Access Compliance Report

Public Rights-of-Way

| Intersection ID: 10034320 | Main Street: PERIMETER_PY | Cross Street: N/A | Location: NE |
| ADA ID: 0AFC7D3C28BF | Ramp Type: Perp | Initial Pass/Fail: Fail | Overall Compliance: No |

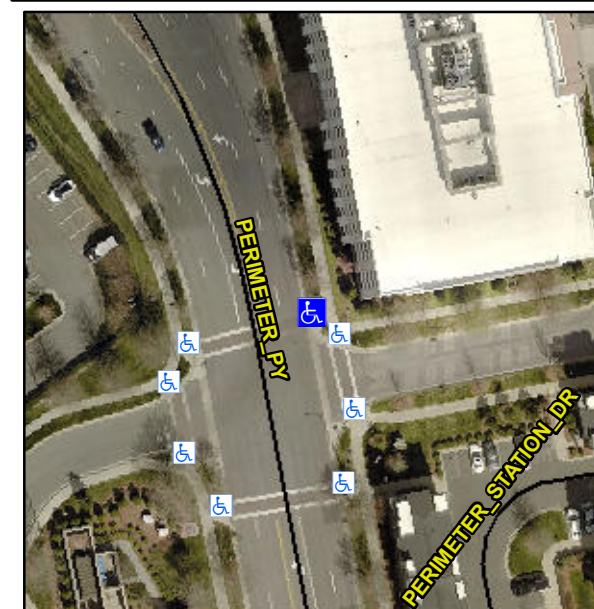
Not Found, R304.5.1, R304.2.2

| Compliance | Description | Data | Compliance | Description | Data |
|------------|-----------------------|------|------------|-----------------------------|------|
| N/A | Ramp Length (in) | 88.0 | No | Ramp Slope (%) | 8.7 |
| No | Ramp Width (in) | 47.0 | Yes | Ramp XSlope (%) | 2.4 |

Remove & Replace Entire Ramp.
